City of Tualatin

SUBDIVISION REVIEW FINDINGS AND DECISION FOR SB 13-02, MISSION WOODS

This staff report recommends approval of an 8-lot plan for the Mission Woods Subdivision, as shown on plans dated May 16, 2013 attached as Exhibit B, with conditions of approval as outlined in the staff report.

MISSION WOODS
 TUALATIN, OR
 SITE PLAN / PRELIMINARY PLAT

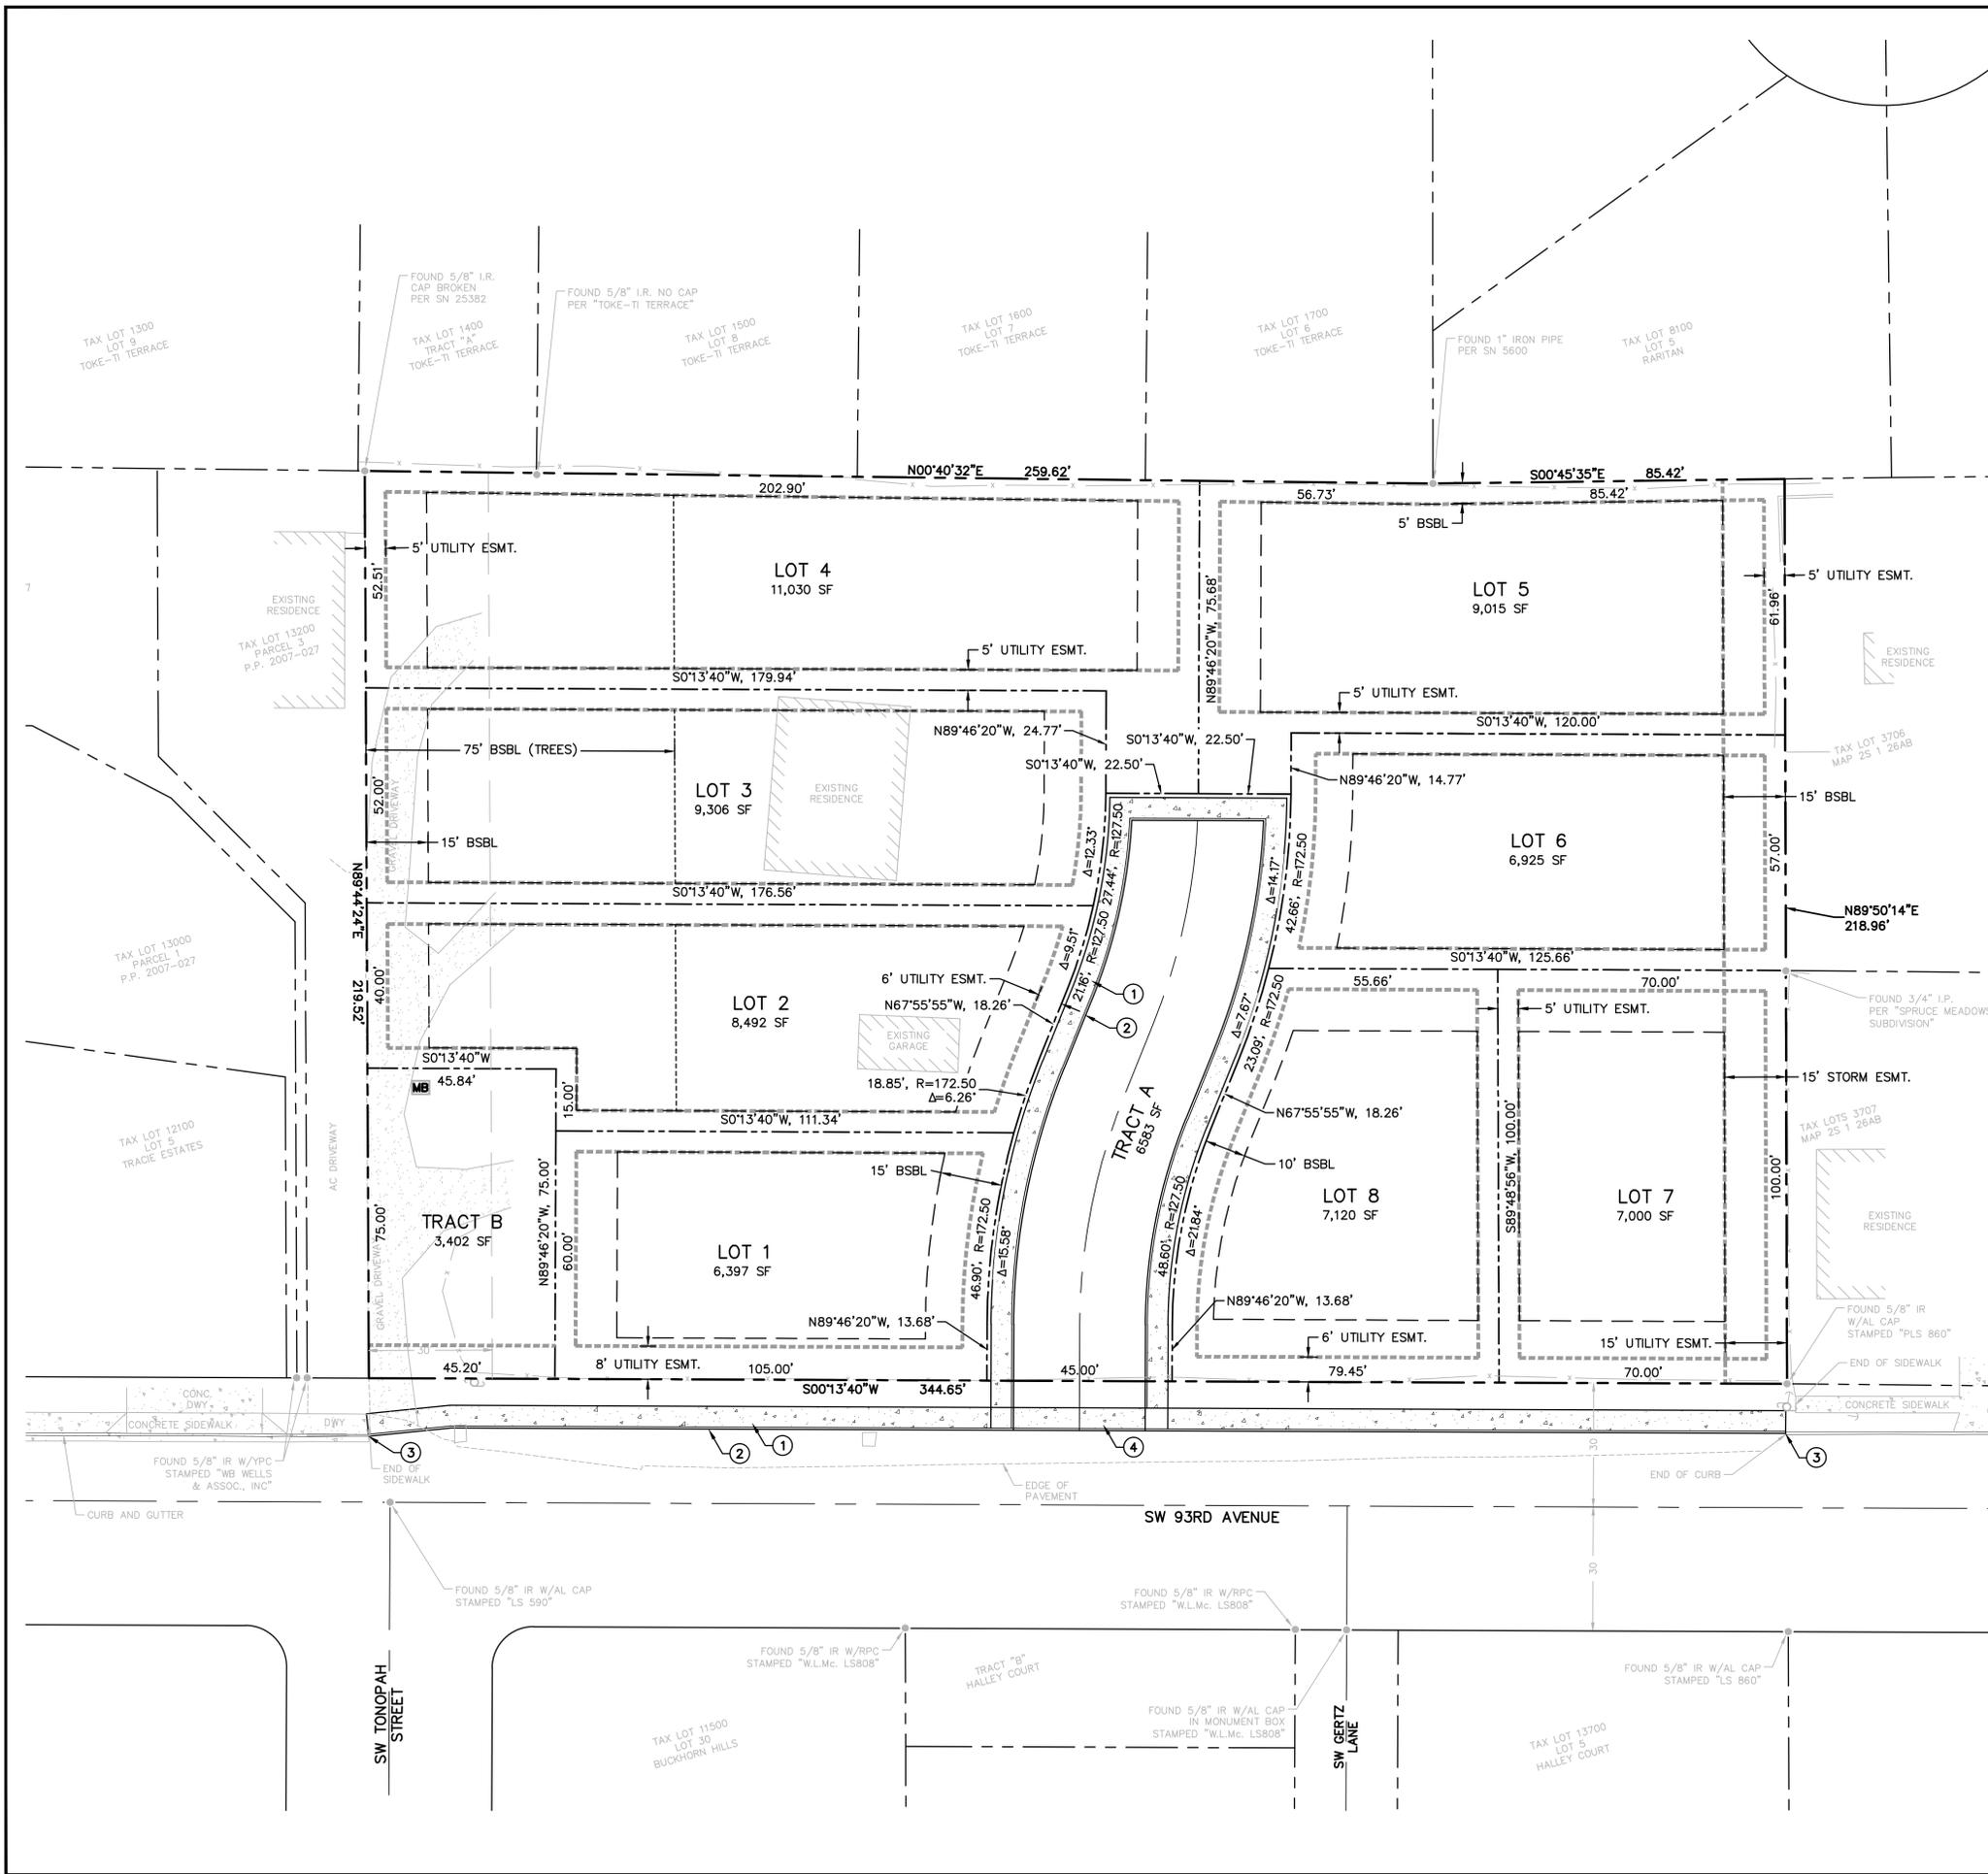
The submitted narrative indicates lots 2 through 6 sharing accesses through the private tract to SW 93rd Avenue via shared easements. This is less than the maximum of 6, therefore acceptable. This tract is 144 feet long, less than the maximum of 250 feet. This is acceptable. The applicant will need to submit a copy of the recorded private shared access easements and maintenance agreement for the private tract, for review and approval. The applicant will need to submit final plans showing all lot accesses, for review and approval.

Note: The maximum number of lots that may access a private tract is 6. Currently only 5 lots are proposed to have access. The applicant may allow for either lot 1 or 8 to access the private tract in addition to lots 2 through 6.

The plans show construction of SW 93rd Avenue which includes dedication of 50-feet of right-of-way and construction of a half-street with curb-tight sidewalk and planter. This section of SW 93rd Avenue is the last in the neighborhood to be developed. The remaining adjacent areas were constructed with curb-tight sidewalks. The proposal to include a curb-tight sidewalk fits the surrounding area. This is acceptable. The applicant will need to submit final plans of SW 93rd Avenue that include a curb-tight sidewalk, for review and approval. The applicant will need to dedicate right-of-way for SW 93rd Avenue to provide 25 feet from centerline (corresponding to total right-of-way width of 50 feet), for review and approval.

- PFR-5 The applicant shall submit final plans showing all lot accesses, for review and approval.
- PFR-6 The applicant shall submit final plans of SW 93rd Avenue that include a curb-tight sidewalk, for review and approval.

MISSION WOODS
TUALATIN, OR
GRADING AND TREE PROTECTION PLAN

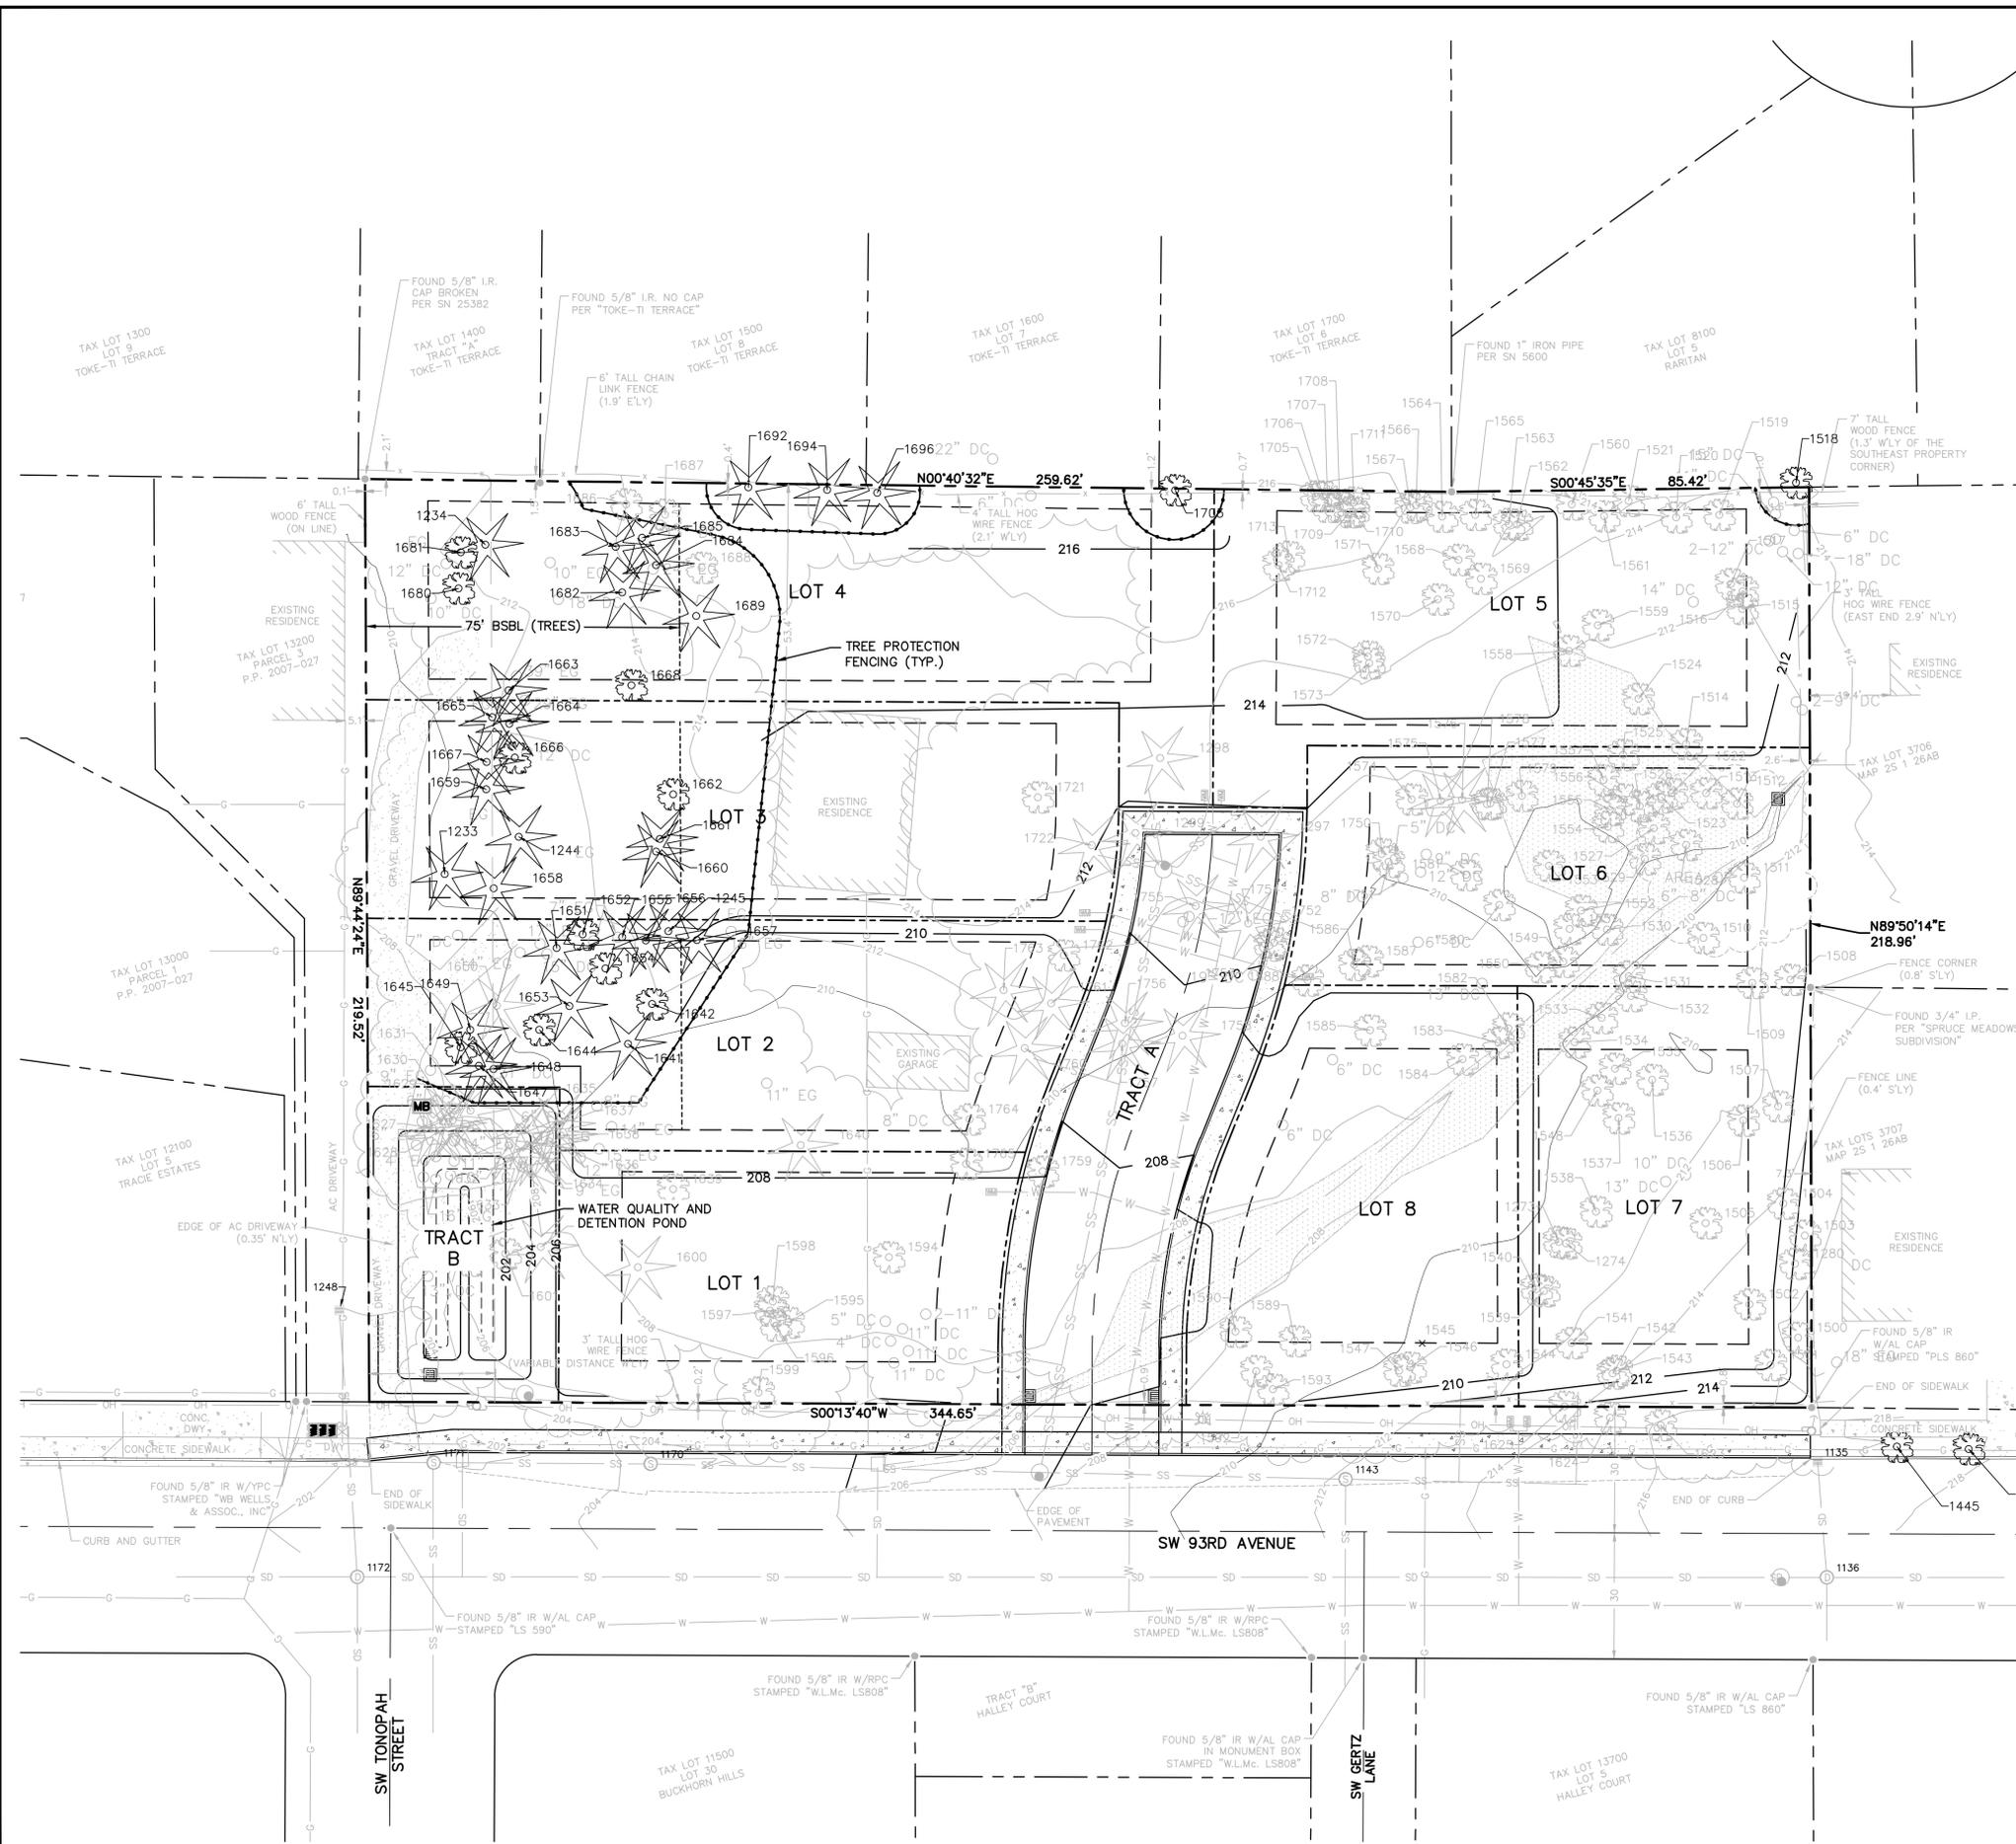
The applicant has submitted an arborist report dated April 29, 2013. This report recommends 41 trees for retention. This is acceptable. Trees that will not be removed as a part of the proposed development and trees on adjacent properties that may be affected by the proposed grading activities and equipment will need to be protected. The applicant will need to show tree protection around trees to be retained, for review and approval.

- PFR-16 The applicant shall obtain a City of Tualatin erosion control permit.
- PFR-17 The applicant shall show tree protection around trees to be retained, for review and approval.
